Access Compliance Report

Public Rights-of-Way

Intersection ID: 9490	Main Street: BARRINGTON_DR	Cross Street: CRAFTSBURY_DR	Location: S
ADA ID: 5033F2AAC632	Ramp Type: Perp	Initial Pass/Fail: Pass	Overall Compliance: No
		Severity Score: 14

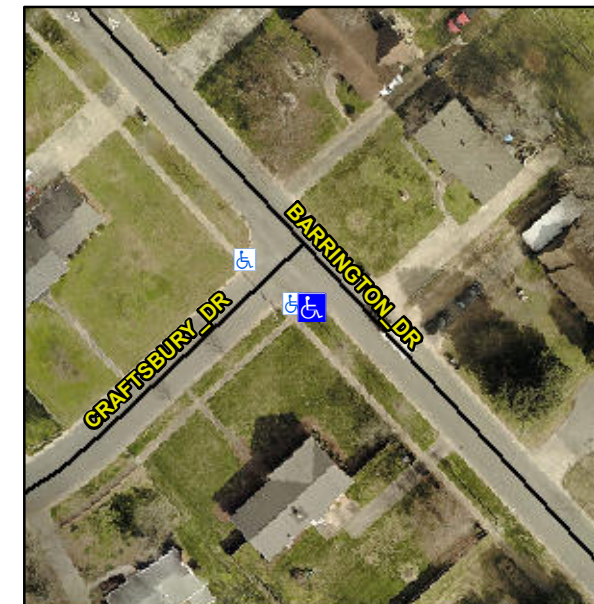
Not Found, R304.2.1, R304.5.3, R305, R302.7

Compliance	Description	Data	Compliance	Description	Data
N/A	Ramp Length (in)	71.5	Yes	Ramp Slope (%)	7.5
Yes	Ramp Width (in)	81.0	Yes	Ramp XSlope (%)	0.3
N/A	Flare Type LT	Sloped	N/A	Flare Type RT	N/A
N/A	Flare Slope LT (%)	8.1	Yes	Flare Slope RT (%)	0.8
N/A	Flare Traversable LT?	No	N/A	Flare Traversable RT?	Yes
No	Landing Length (in)	47.0	No	DWS Provided?	No
No	Landing Width (in)	47.5	N/A	DWS Contrast?	No
Yes	Landing Slope (%)	0.3	N/A	DWS Length (in)	N/A
No	Landing X Slope (%)	3.6	N/A	DWS Full Width?	No
N/A	Landing Curb? (Y/N)	No	N/A	DWS Offset (in)	N/A
N/A	Shared Landing?	Yes			
No	Gutter Ponding?	Yes	Yes	Gutter Slope (%)	1.5
Yes	Gutter Lip Ht (in)	0.0	Yes	Gutter X Slope (%)	0.4
N/A	Painted X Walk1?	No	N/A	Painted X Walk2?	N/A
	X Walk 1 Direction	To E		X Walk 2 Direction	N/A
N/A	X Walk 1 Width (in)	N/A	N/A	X Walk 2 Width (in)	N/A
	X Walk 1 Slope (%)	3.8		X Walk 2 Slope (%)	N/A
	X Walk 1 X Slope (%)	0.3		X Walk 2 X Slope (%)	N/A

N/A	Ramp inside XWalk1?	N/A	N/A	Ramp inside XWalk2?	N/A
	Road Slope (%)	N/A	N/A	Clear Space?	Yes
	Road X Slope (%)	N/A	N/A	Clear Space to XWalk (in)	N/A
Yes	Any Obstructions?	No	Yes	Storm Grate/Utility Hazard?	No
	Obstruction Type			Storm Grate/Utility Type	
		N/A			N/A
			Yes	Surface Condition? (G/P)	Good

Remove & Replace Entire Ramp.
